PLAN OF SEPTIC SYSTEM REPAIR
37 BAY ROAD, AMHERST, MA 01002

SEYMOUR AND ALICE EPSTEIN
37 BAY ROAD, AMHERST, MA 01002

RE: Septic System --37 Bay Road

Re: Septic system repair plan for 37 Bay Rd., Seymour & Alice Epstein, owners.

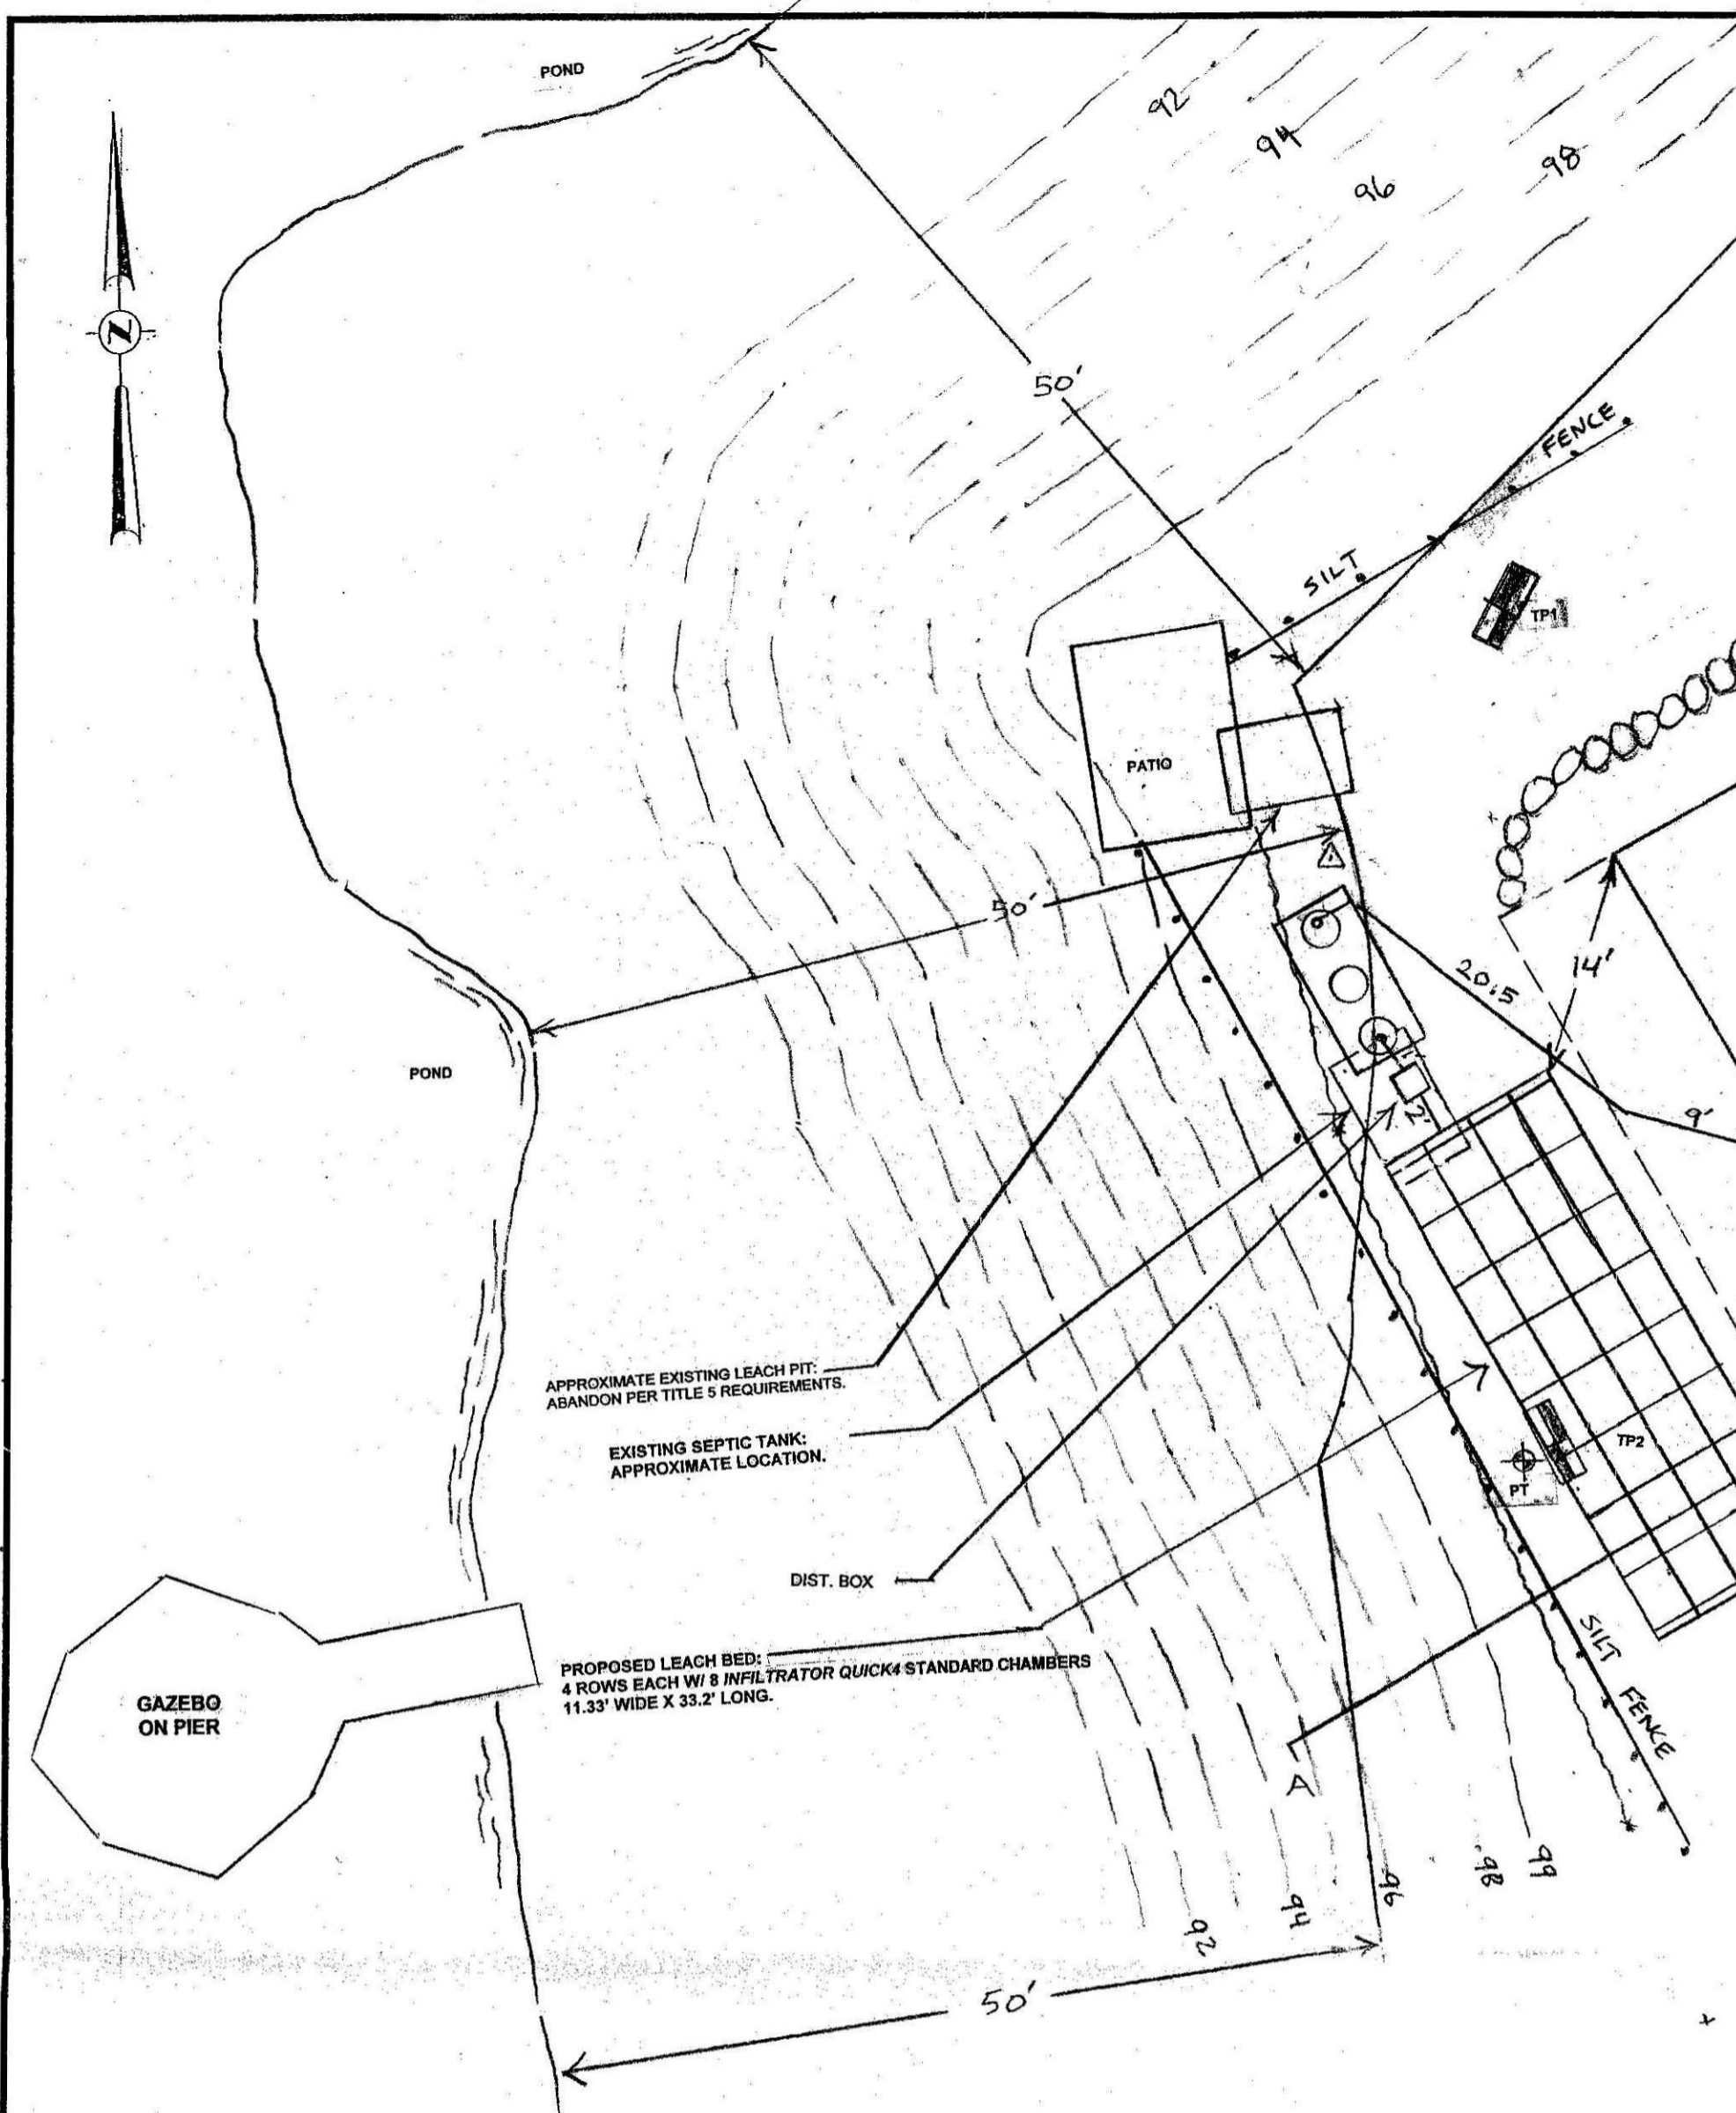
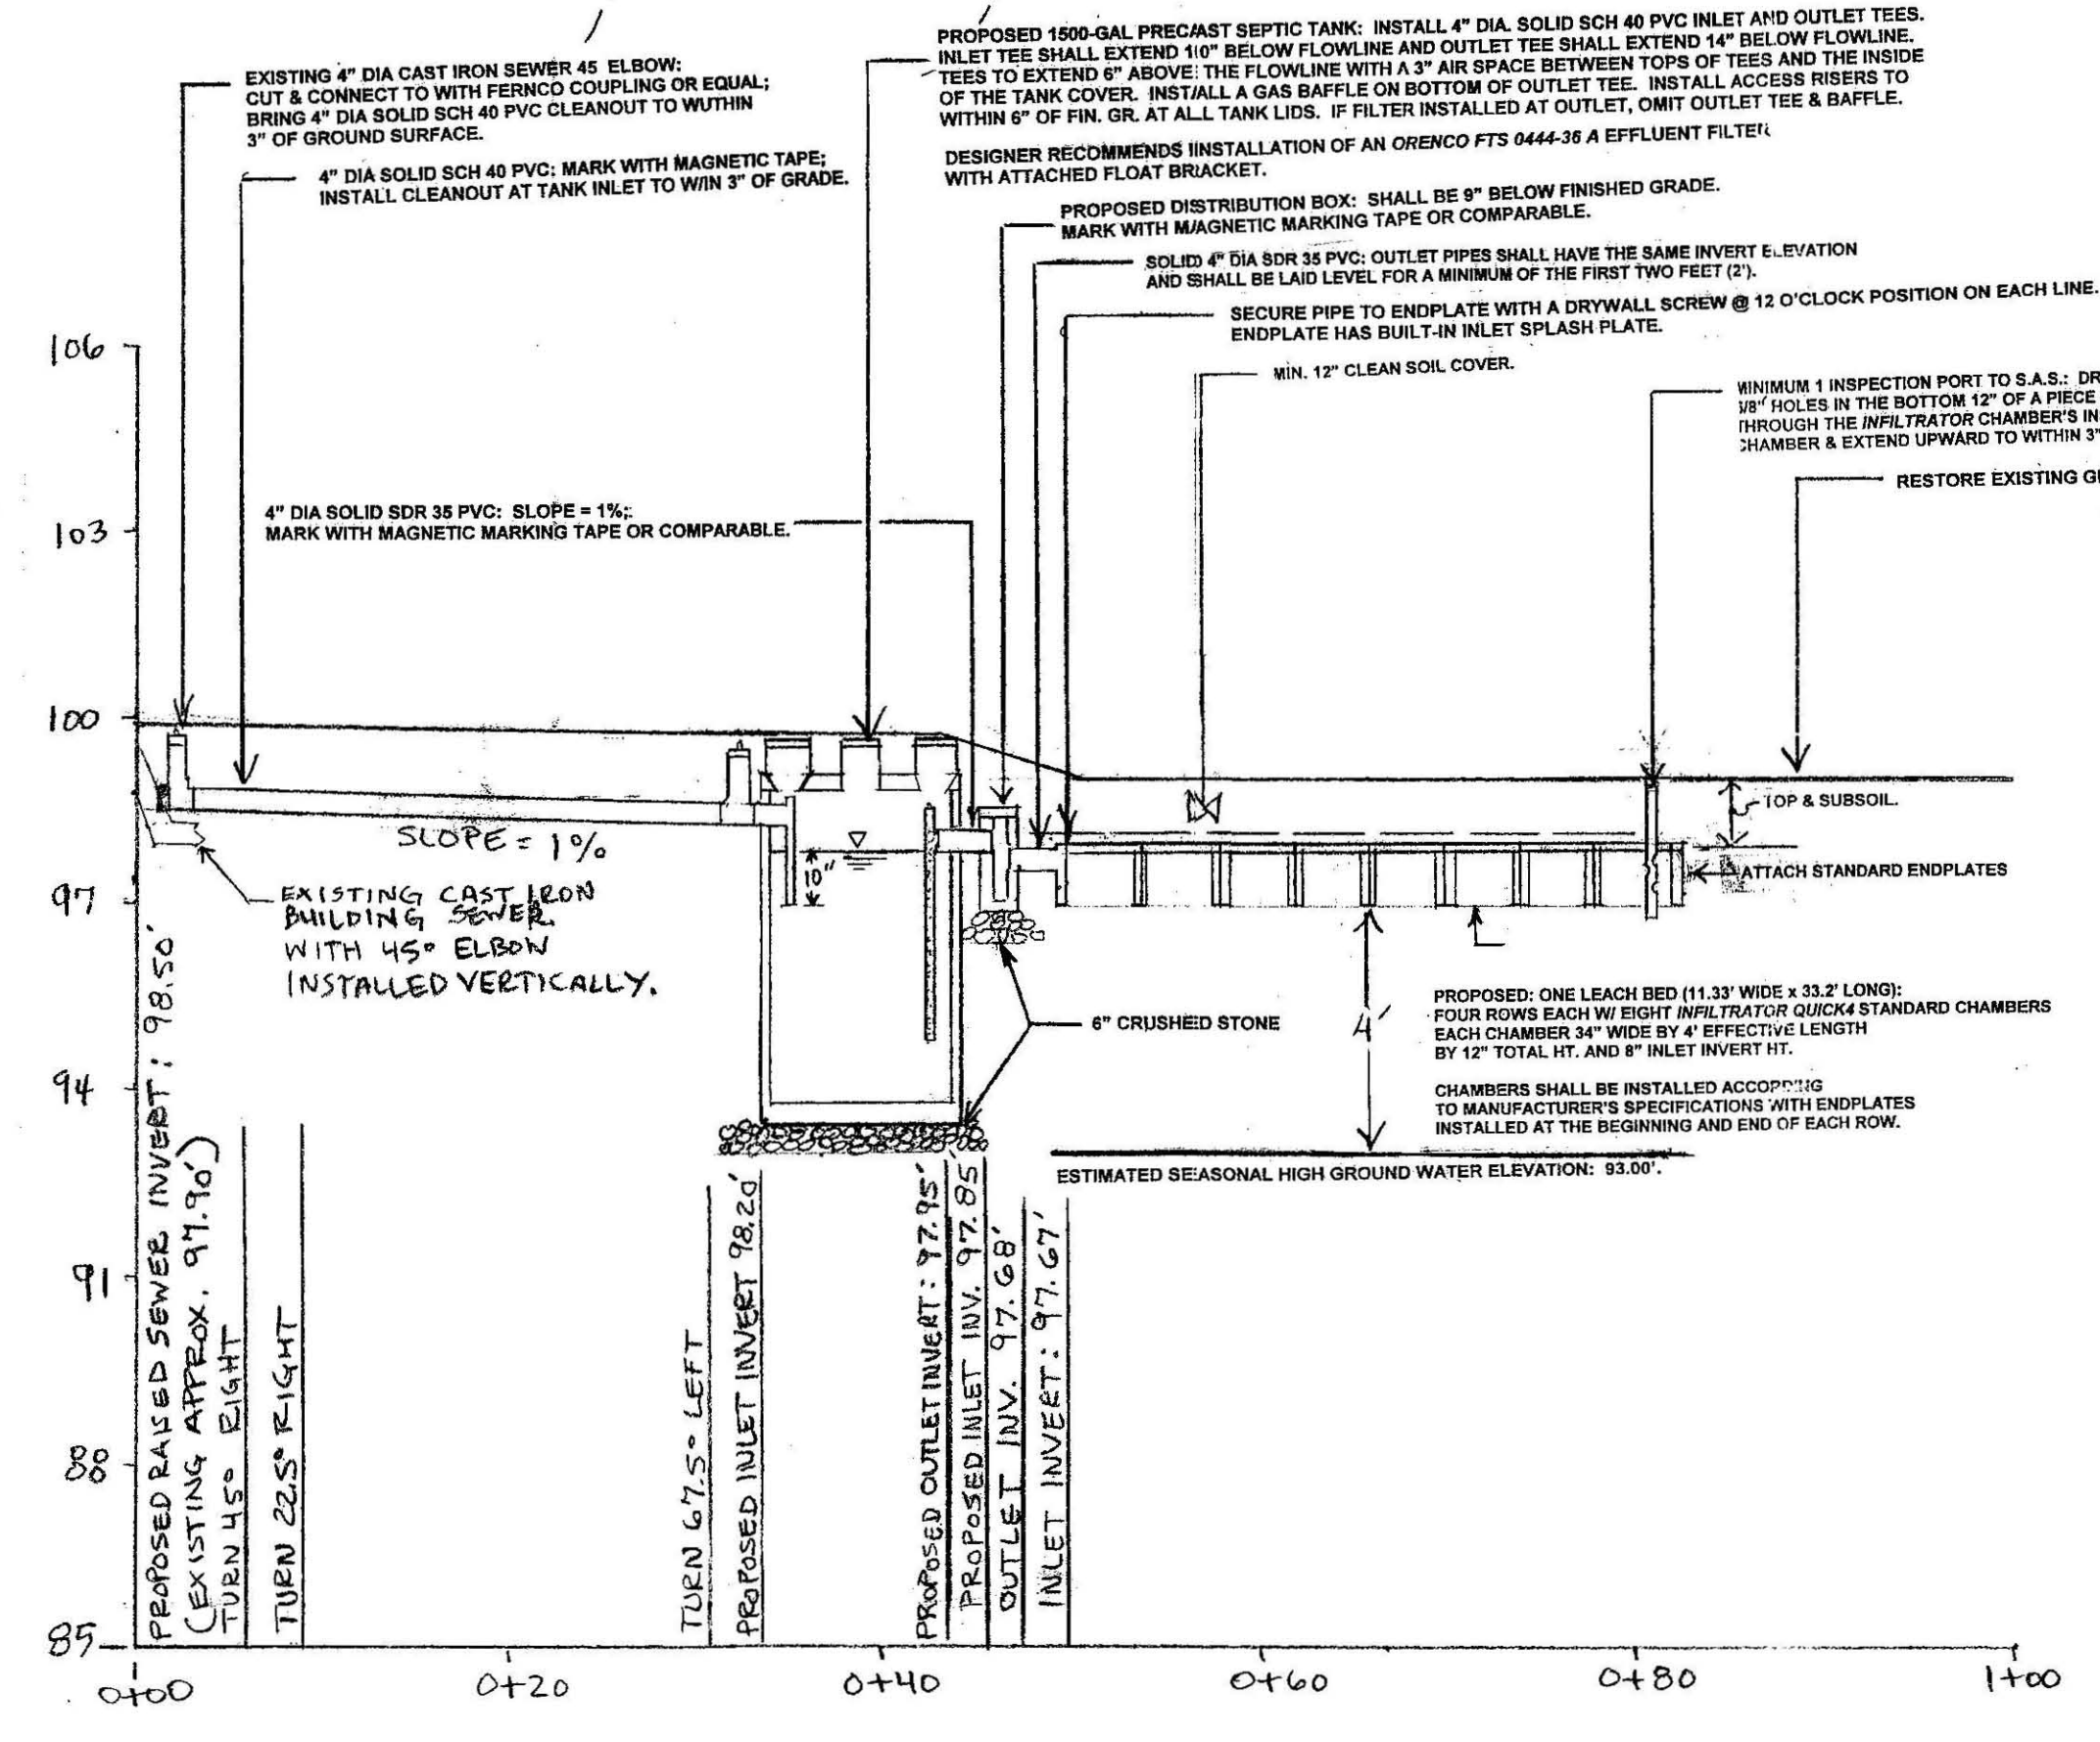
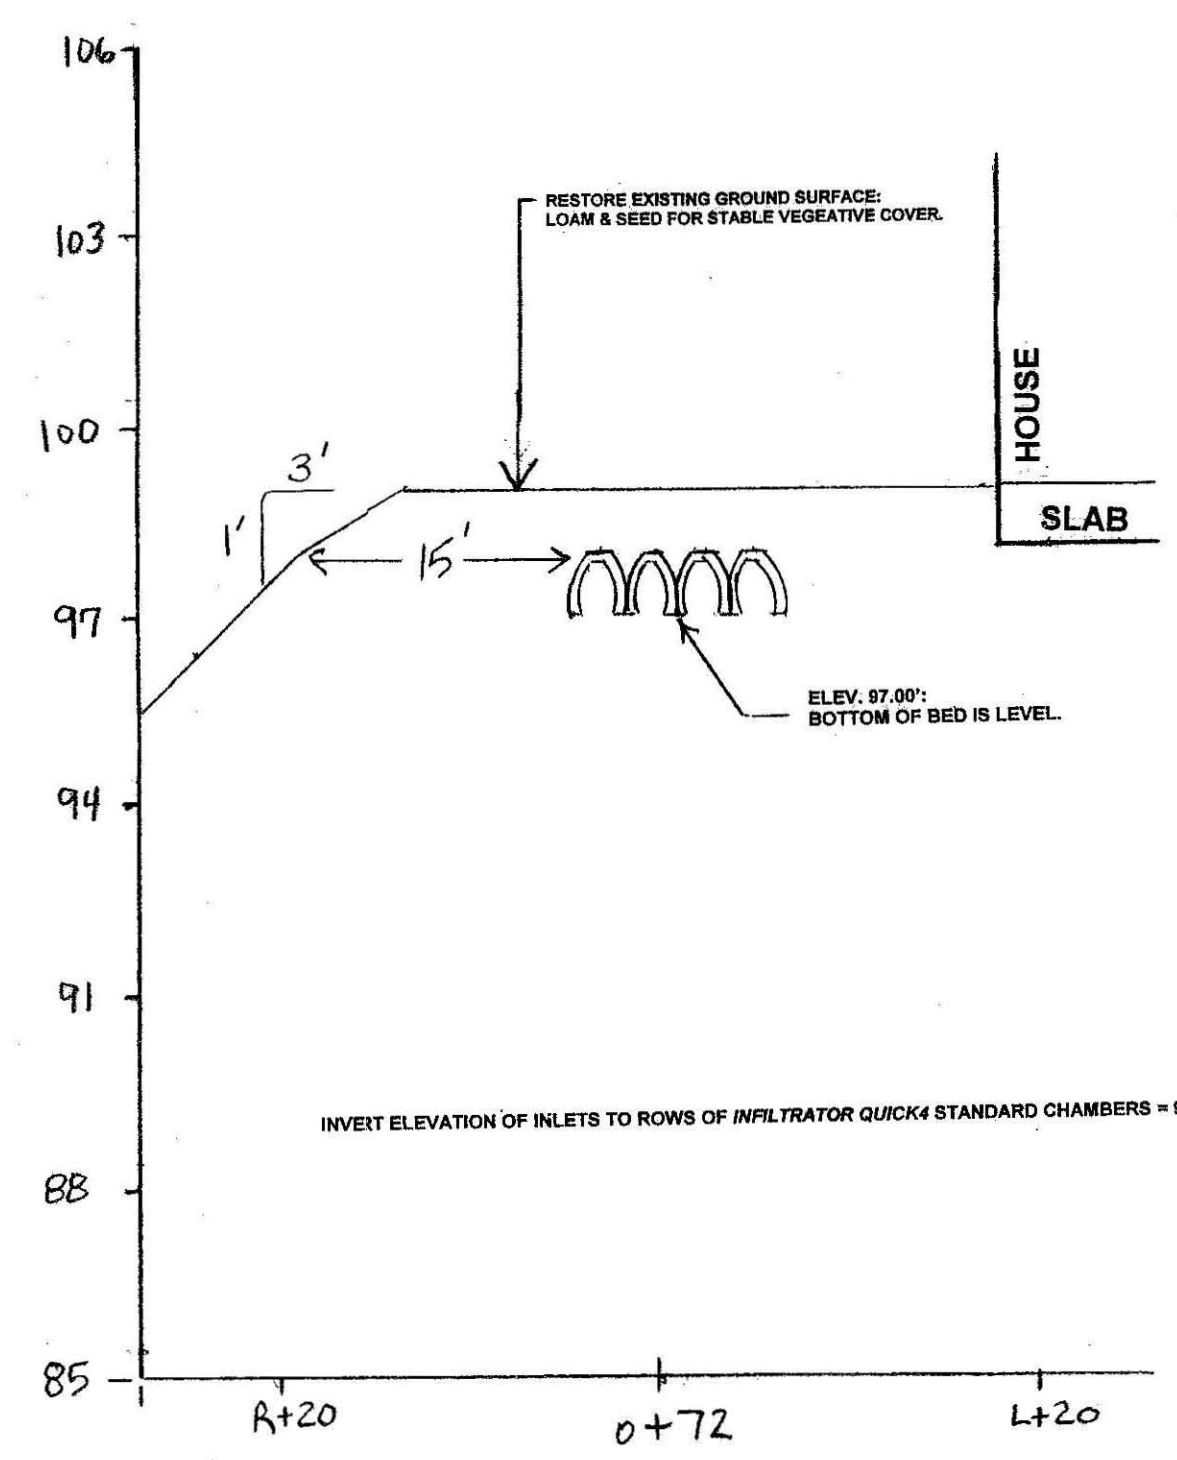
We have revised the plan referenced above. We re-located the leach bed so that it will be directly behind the house rather than off to the side of the house. We changed the system location when, in preparation for the Conservation Commission's site visit, we staked out the original location and saw that the very end of the outer row of *Infiltrator* chambers extended into an area with steeper topography and mature trees.

To make the new location work we had to raise the elevation of the leach bed about five-inches to maintain a four-foot water table separation. To achieve this we had to propose that a new 1500-gallon septic tank be installed at an elevation higher than that of the existing 1000-gallon tank.

To verify that a tank and the pipe to the house can be installed higher in the ground we dug up the pipe at the house to ascertain its elevation. The elevation of this pipe allows the tank and pipe to the house to be installed at the elevation proposed in the revised plan but no higher.

Despite the higher leach bed we can provide the required cover above the leach bed without the need for fill to raise the finished grade.

Since the proposed leach bed is only ten-feet from the house's slab foundation and since this area is flat, installation of a pump system and a mound to achieve the fifth foot of water table separation would cause surface runoff to flow to the house. Therefore, the plan still requires a Local Upgrade Approval to allow a four-foot rather than a five-foot separation from the estimated seasonally high ground water elevation.

In order to provide a higher level of environmental protection, an Orenco filter will be installed at the septic tank

AS-BUILT SKETCH - SEPTIC SYSTEM LOCATION

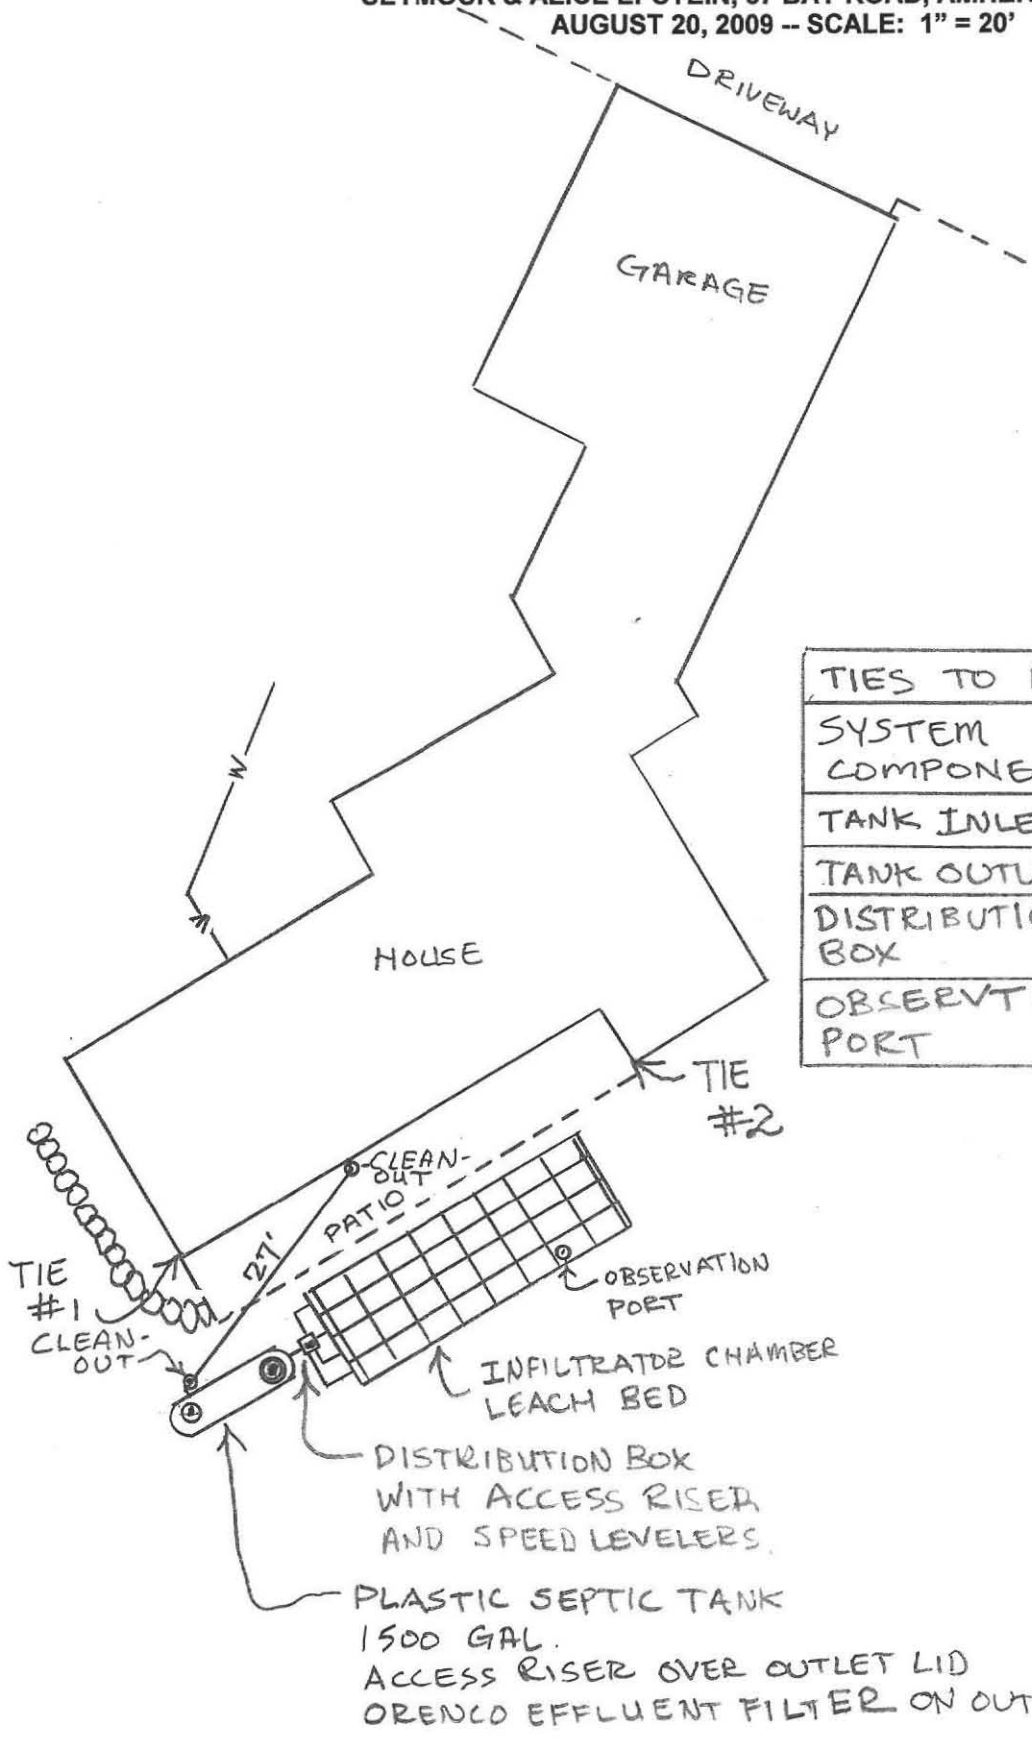
The owners are anxious to receive the COC. If the revised plan dated 8-26-09 is accurate then please submit a letter stating that and this plan may be used for the "as-built."
